REMARKS

Claims 1 to 7, 10 to 12, and 14 to 16 are currently pending in this application. In view of the following remarks, it is respectfully submitted that all of the presently pending claims are allowable, and reconsideration is respectfully requested.

II. Objection and Amendments to the Drawings

Serial No.
09/372,636
Replacement
Sheet

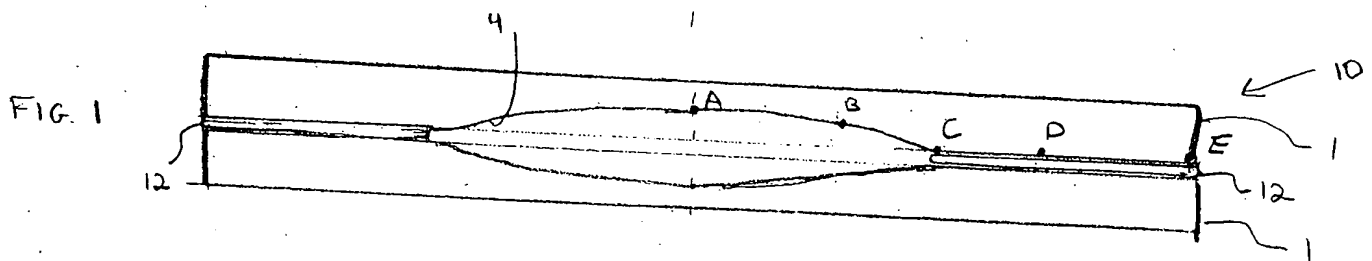
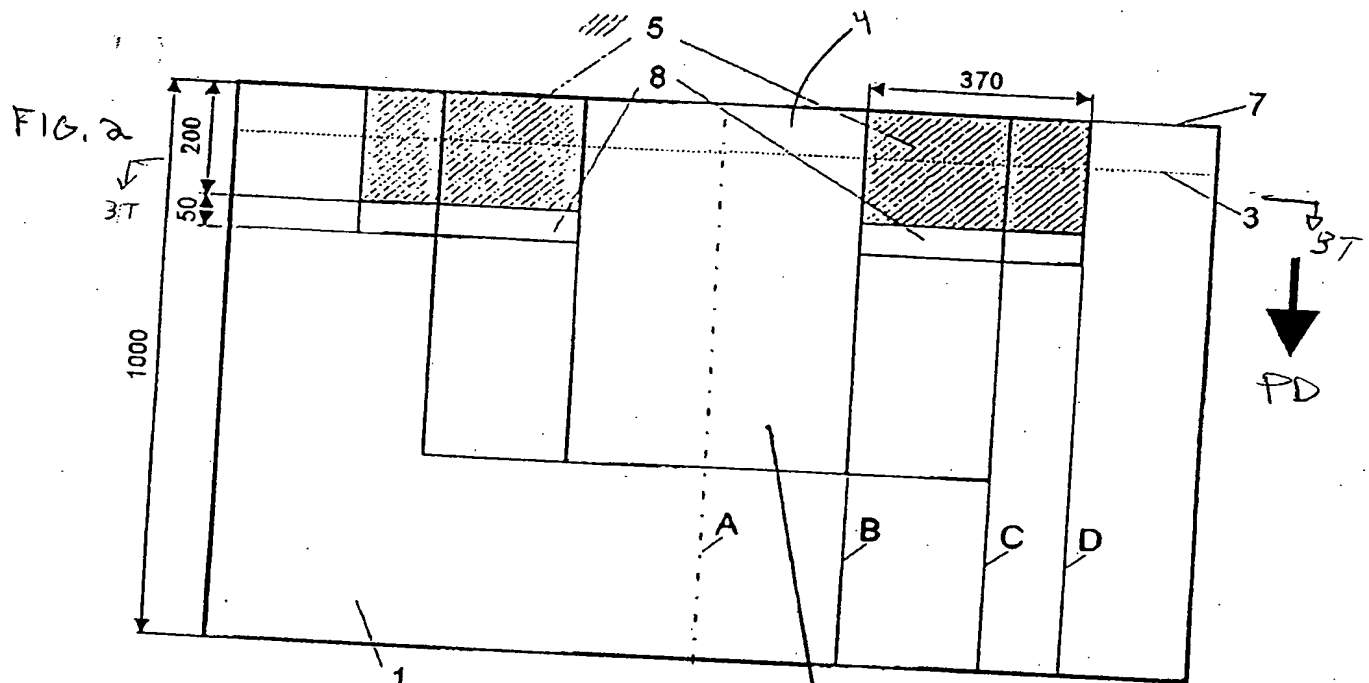
Figure 3 has been amended to more clearly show the varying size of the bore holes, the varying spacing between the bore holes 14 and the varying spacing of the bore holes to the cooling surface along the width of the casting die. No new matter has been added. The Specification states, for example, on page 5, lines 15 to 24 that, as with the cooling channels, the bore holes can be made narrower, spaced closer and brought closer to the pouring surface in the supercritically stressed areas on both sides of the funnel so as to make the cooling surface effectively larger in those areas. See also original claims 12 to 15.

It is believed and respectfully submitted that a person of reasonable skill in the art could without undue experimentation make and/or use the casting die as recited in the present claims. Figure 3 shows cooling bore holes that are smaller, spaced closer to each and to the cooling surface in the portion of the casting die

between lines B and C. Notwithstanding the above, Figure 3 has been amended to clarify the spacing, size and location of the cooling bore holes. It is therefore respectfully submitted that claims 1 to 7, 10 to 12 and 14 to 16 satisfy the requirements of 35 U.S.C. § 112. Therefore, withdrawal of the 35 U.S.C. § 112 rejection and allowance of these claims are respectfully requested.

Serial No.
09/372,636
Replacement
Sheet

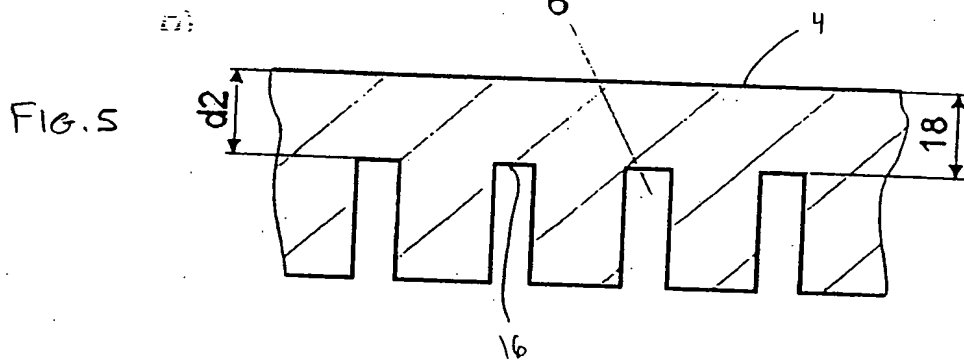
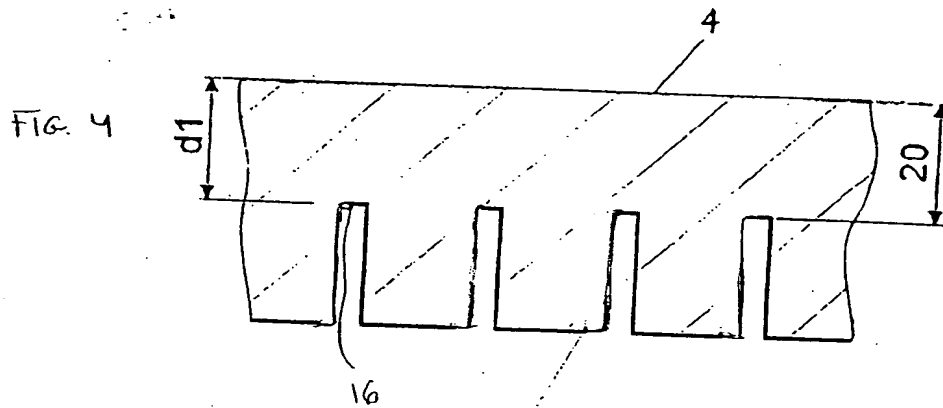
Figure 4 has also been amended so as to narrow the cooling grooves relative to the grooves in Figure 5. No new matter has been added. See original claim 14 and the Specification, for example, at p. 5, lines 15 to 17. Therefore, withdrawal of the objection to the drawings is respectfully requested.

“narrower” is unclear and is deemed to mean “tapering in a conical manner.” Firstly, Applicants submit that the term “narrowing,” in the context of the application, reasonably clearly conveys to one skilled in the art a reduction of width of the cooling grooves. Figures 4 and 5 have been amended to clearly show the reduction of width of the cooling grooves. Secondly, Applicants respectfully disagree with the Examiner’s asserted definition of “narrower” and submit that the ordinary definition of the verb “narrow” is “to lessen in width or extent.” See attached p. 346 of the 1998 Merriam-Webster Dictionary.

width or extent.” See attached p. 346 of the 1998 Merriam-Webster Dictionary. Figures 4 and 5 have been amended to clearly show the reduction of width of the cooling grooves. Figures 4 and 5 show a cross section of the cooling grooves, which run parallel to the pouring direction. Cooling grooves positioned along the width of the casting die (Figure 3) in a thermally and mechanically stressed area, for example, between lines B and C, are narrower (Figure 4) along their length, i.e., have a smaller diameter, than in other portions (Figure 5) along the width of the casting die.
